Panel Reference	PPSSNH-433
DA Number	DA-2023/256
LGA	Willoughby
Proposed Development	Demolition of existing structures and construction of shop top housing development comprising 53 residential units; 5 level basement with 42 car parking spaces, strata subdivision, landscaping and associated works, Nominated Integrated Development - Water Management Act 2000 s90 (WaterNSW).
Street Address	629-639 Pacific Highway, Chatswood
Applicant/Owner	Polytec Australia Four Pty Ltd
Date of DA lodgement	21 September 2023
Number of Submissions	Five (5)
Recommendation	Refusal
Regional Development Criteria - Schedule 6 of the SEPP (Planning Systems) 2021	Development that has a capital investment value of more than \$30 million.
List of all relevant s4.15(1)(a) matters	<ul style="list-style-type: none"> • State Environmental Planning Policy (Biodiversity and Conservation) 2021 • State Environmental Planning Policy (Resilience and Hazards) 2021 • State Environmental Planning Policy (Transport and Infrastructure) 2021 • State Environmental Planning Policy (Planning Systems) 2021 • State Environmental Planning Policy (BASIX) 2004 • SEPP No 65 - Design Quality of Residential Apartment Development and NS

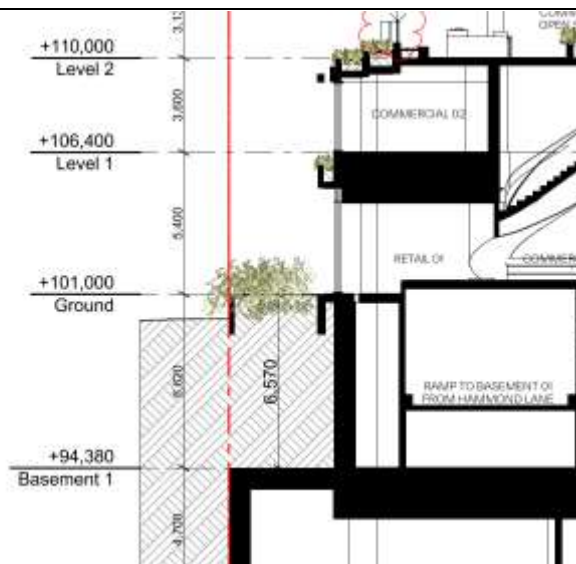
Landscaping	<p><u>Deep soil</u></p> <p>The proposal does not meet the DCP controls for deep soil as the basement extends to all boundaries at the lower basement level.</p> <p>The Basement 1 does not extend to the boundary on the Pacific Highway Frontage, providing a soil depth of 5.6m - 6m is provided. Whilst this depth is considered suitable to support the proposed trees (<i>Waterhousia floribunda</i> “Green Avenue”, Weeping Lilly Pilly), the intent of the deep soil zone is to provide a wider deep soil zone for larger street trees.</p> <p><i>Section showing Basement 2 and below extending to the boundary on the Pacific Highway side.</i></p>

Control 7. Deep soil planting is to be provided within the 4m setback to Pacific Highway. Deep soil plantings include trees and shrubs, and are to be unimpeded by buildings or structures below ground.

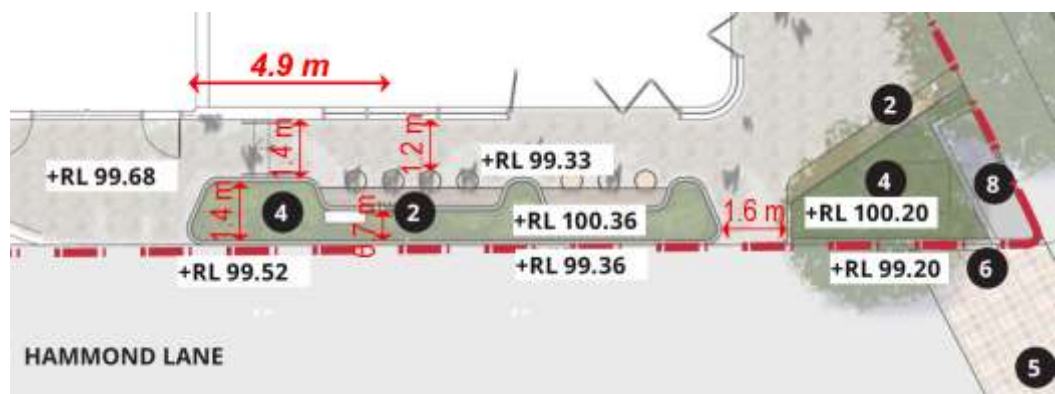
The landscape plans indicate the Council verge to be paved with two 1m wide strips of garden bed to be planted with grasses and provides 4 new street trees on Gordon Avenue. *Plantanus acerifolia* (London Plane) is proposed. This species does not align with Council's Street Tree Masterplan. The London Plane trees are to substituted for *Tristaniopsis laurina* 'Luscious' (Water Gum). The nature strip planting shall have a minimum width of 1.5m from the back of the kerb.

The redundant driveway crossings and 2 new street trees are to be planted along the Pacific Highway of the following species; *Eucalyptus paniculata* (Grey Ironbark). Turf to be provided between the back of the kerb and the footpath.
